Re: Docket No. 04-SPPE-01

**BEFORE THE
ENERGY RESOURCES CONSERVATION
AND DEVELOPMENT COMMISSION
OF THE STATE OF CALIFORNIA**

**RIVERSIDE ENERGY RESOURCE CENTER
SMALL POWER PLANT EXEMPTION
RESPONSE TO CURE DATA REQUESTS SET 1
04-SPPE-01**

Visual Simulation Ultimate Combined Cycle

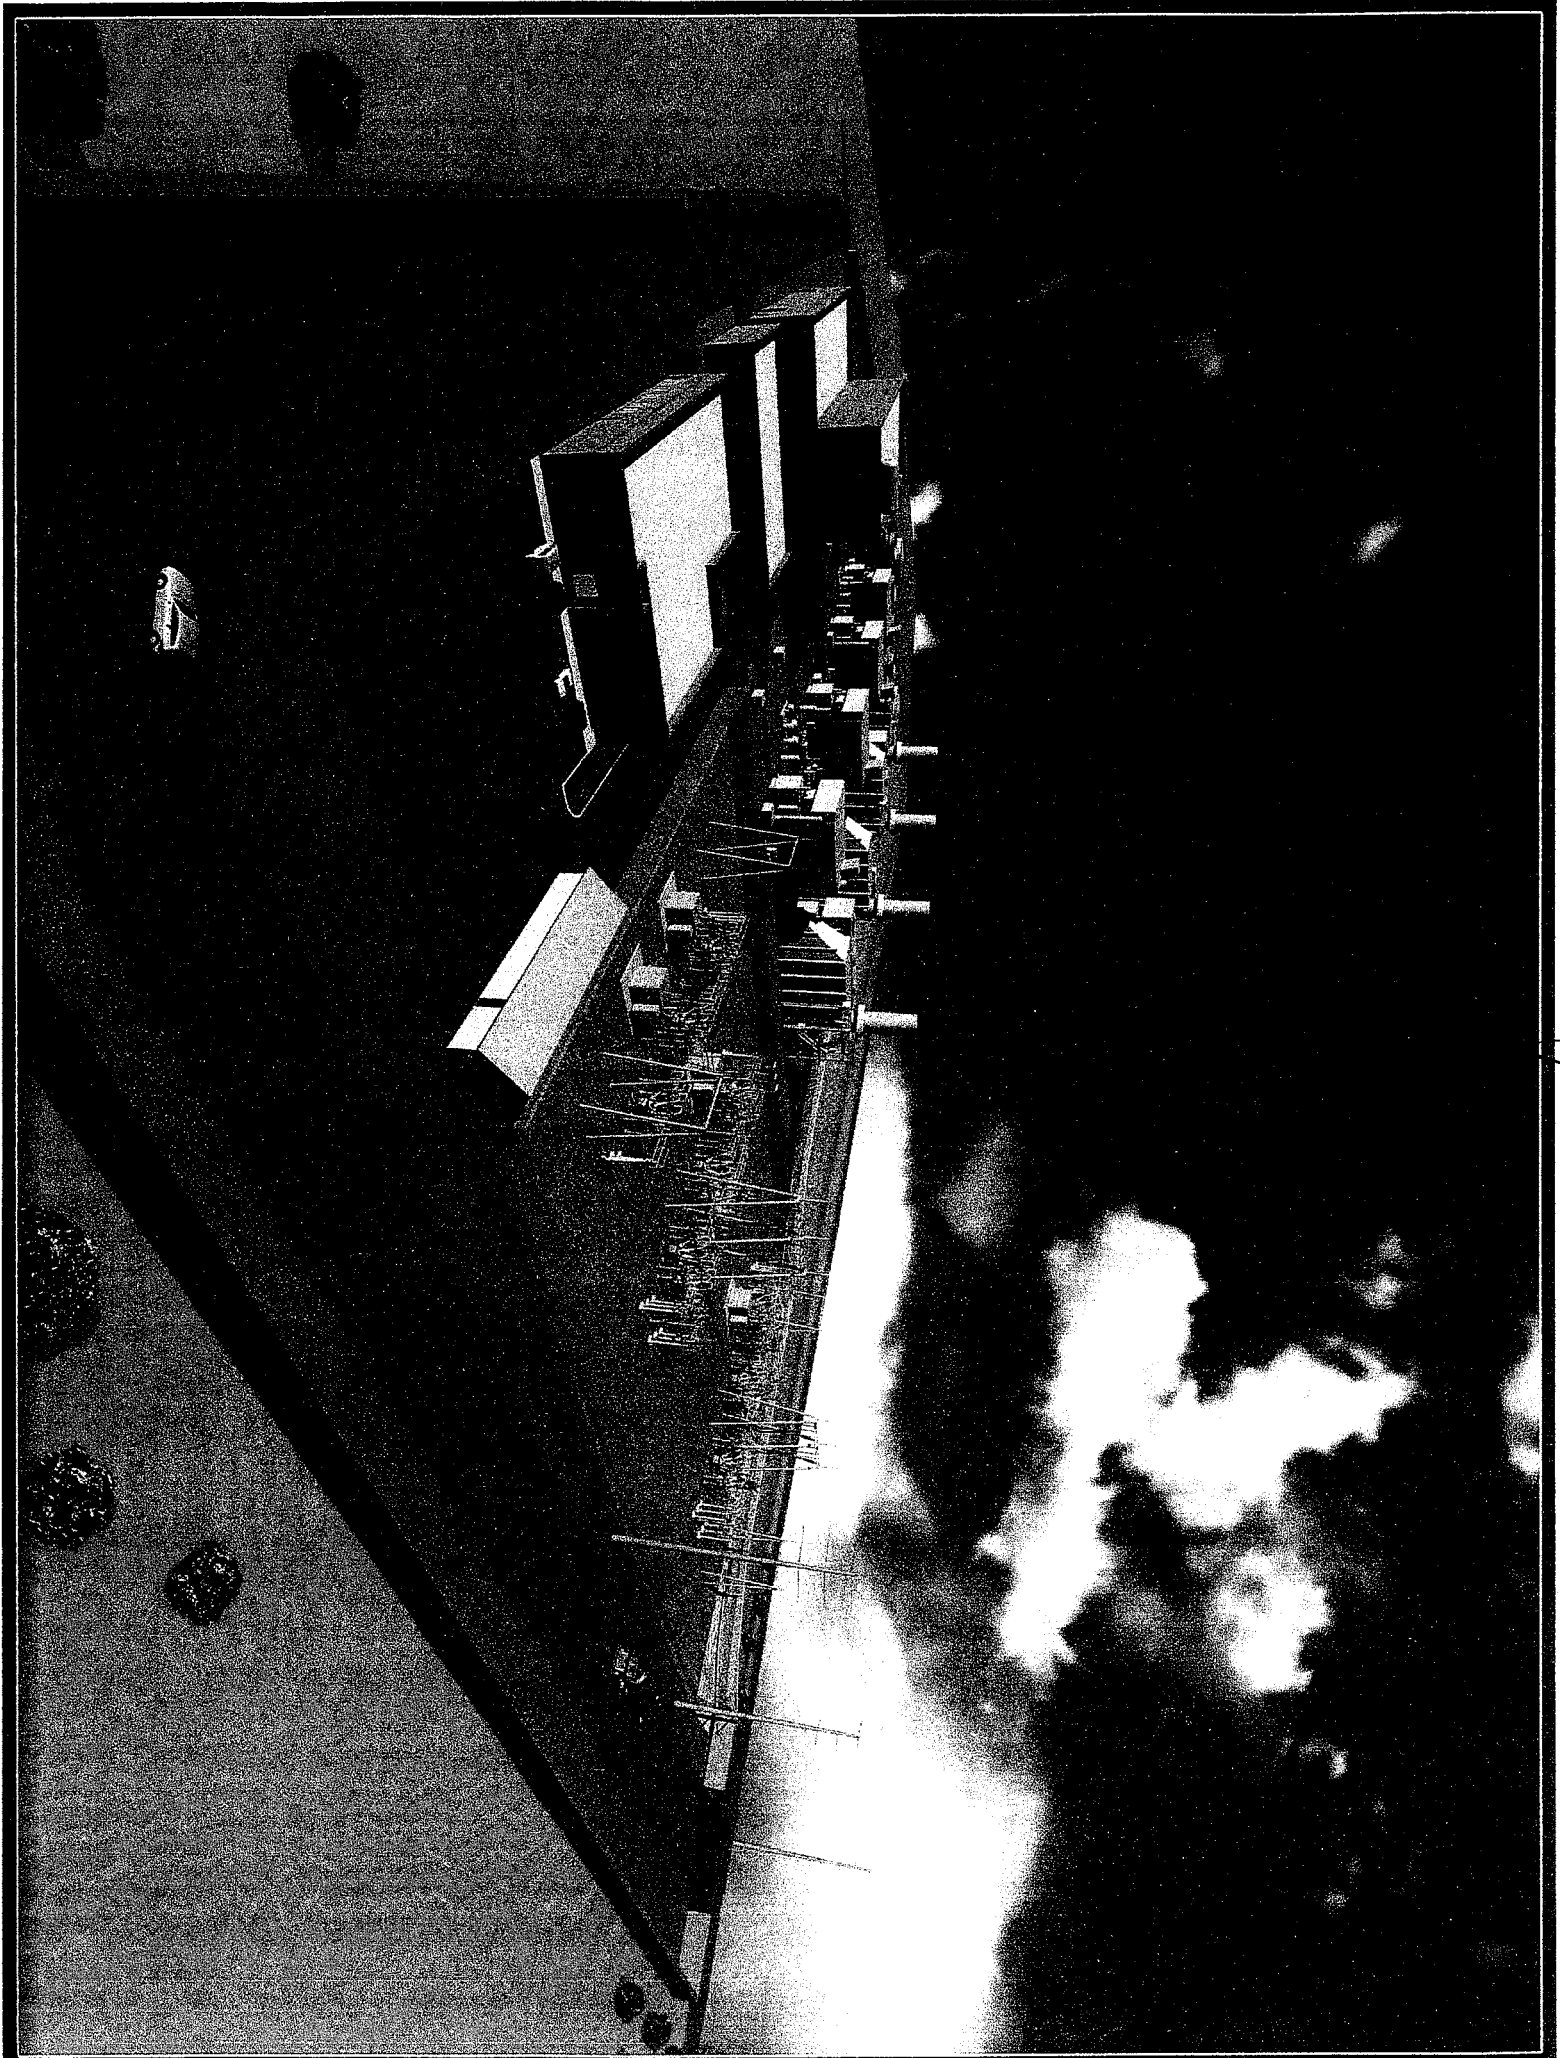
- 1.a Please provide a full visual and written description of the proposed Units 3 and 4, including, but not limited to, their size, configuration, generating capacity, and location in relation to Units 1 and 2.

1.e Please provide any and all documents related to the expansion of the Project beyond Units 1 and 2.

Response: There are no specific plans or commitment to Units 3 and 4 at this time. Since the site was larger than needed for two simple cycle units, it was only prudent to layout the site to allow for future growth if needed. To that end, we considered what a comfortable maximum build out could be and developed a site layout illustrating four LM6000s in combined cycle as a proxy. This was only done so as not to preclude future expansion in the event it is ever considered. That General Arrangement, single line drawing, and the corresponding "bird's eye view" visual simulation are also included as a part of this response.

Response: We are providing the General Arrangement, single line drawing, and the corresponding "bird's eye view" visual simulation that were developed as a part of our response to Data Request 1.a.
